RESOLUTION R-74-06 A RESOLUTION APPROVING ADDENDUMS TO ORCHARD POINTE COMPREHENSIVE DEVELOPMENT PLAN

Orchard Pointe Comprehensive Development Plan

Addendum 1

Expansion and Clarification of Residential Development Opportunities and Street Re-alignment

Hardrock Road Re-alignment

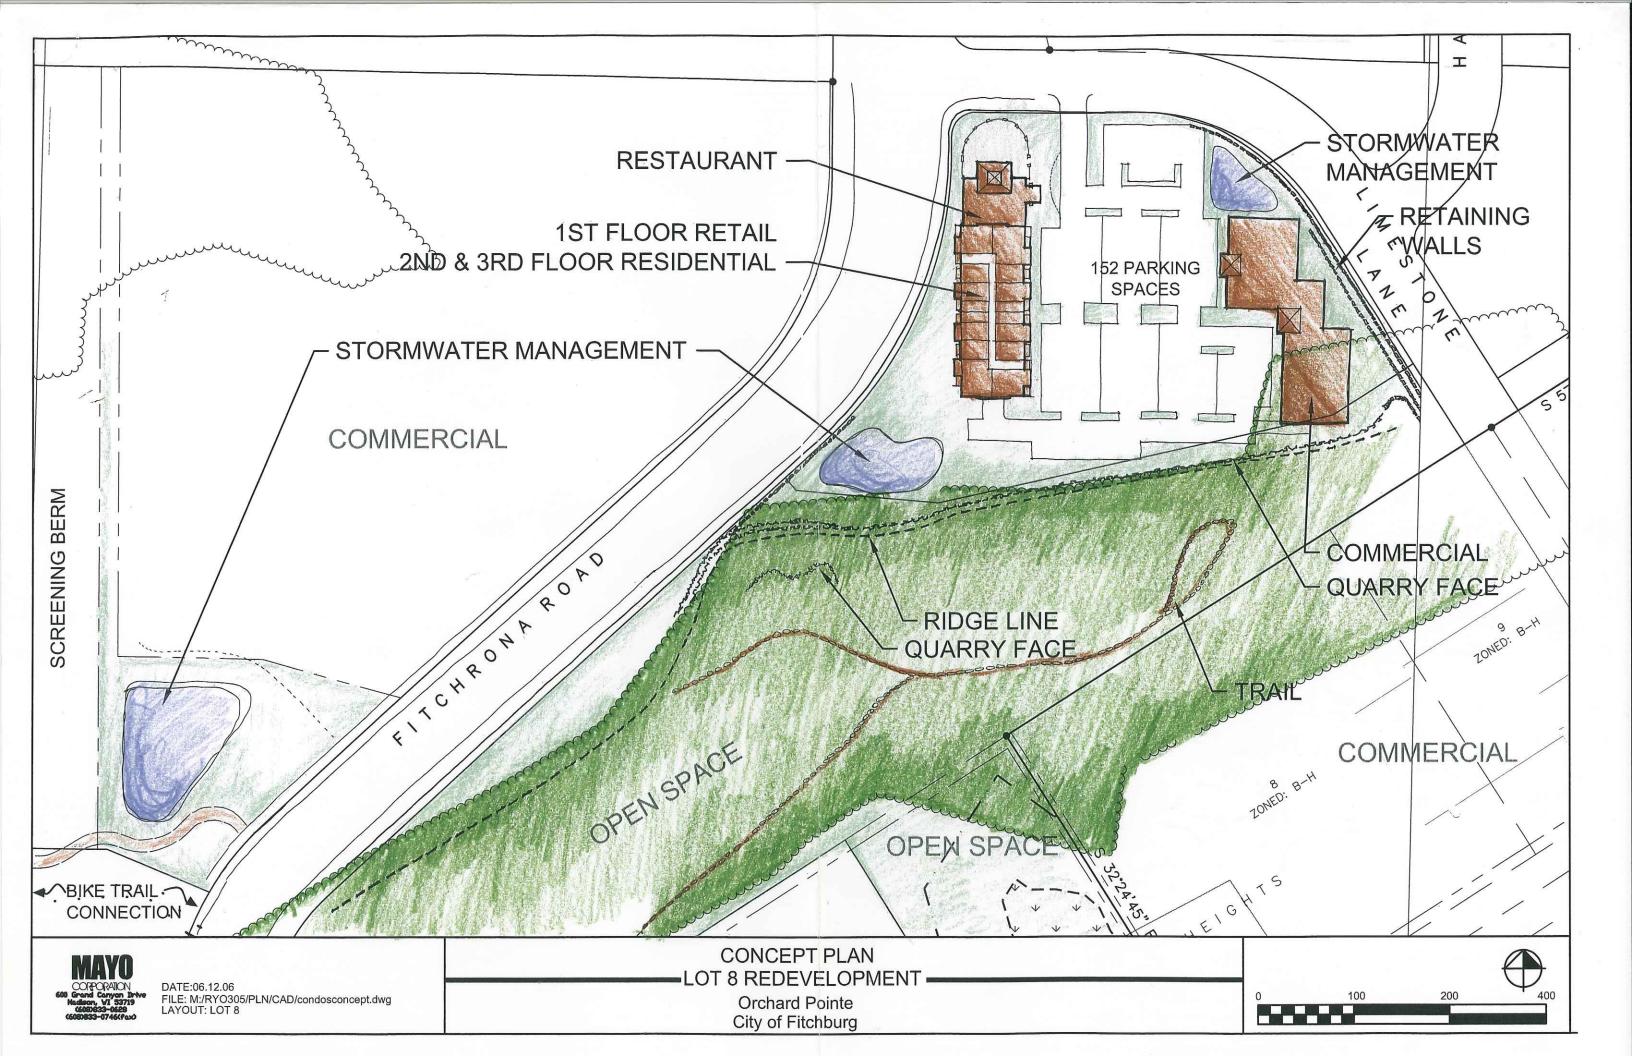
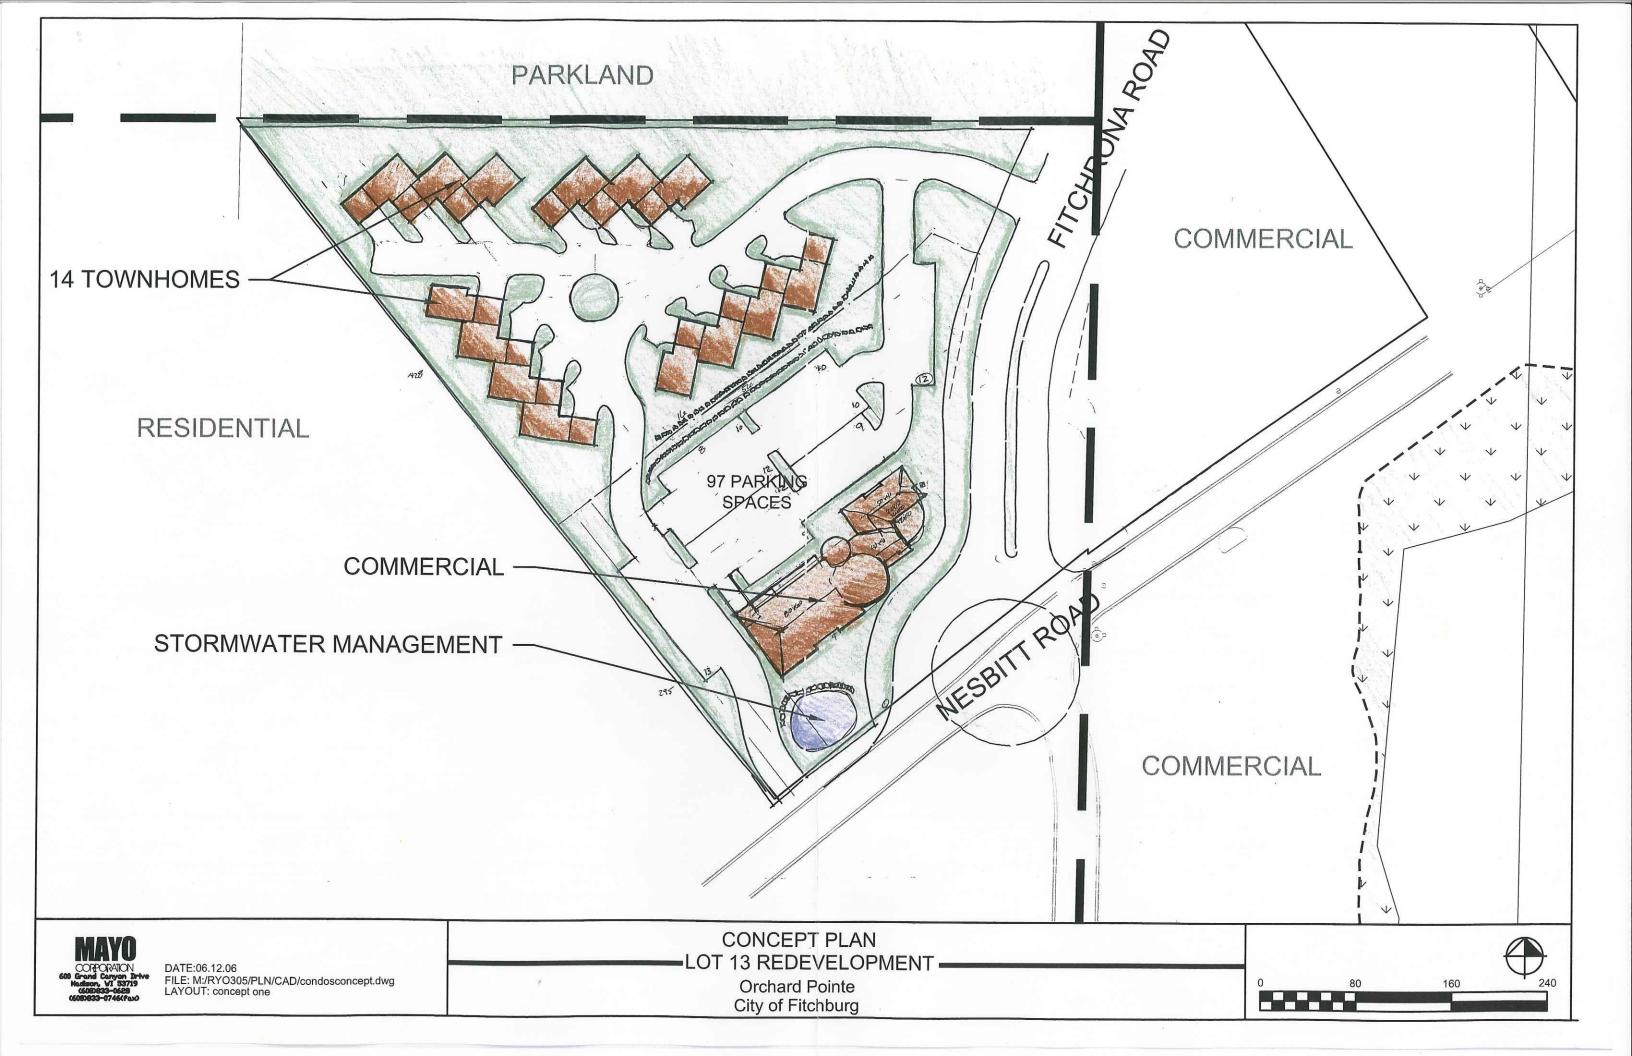
This addendum also incorporates the re-alignment of Hardrock Road shown on the revised preliminary plat per the agreements between the landowners of the former "golf dome" property and the adjoining lands to the East. This re-alignment has only a negligible impact in terms of over all development characteristics.
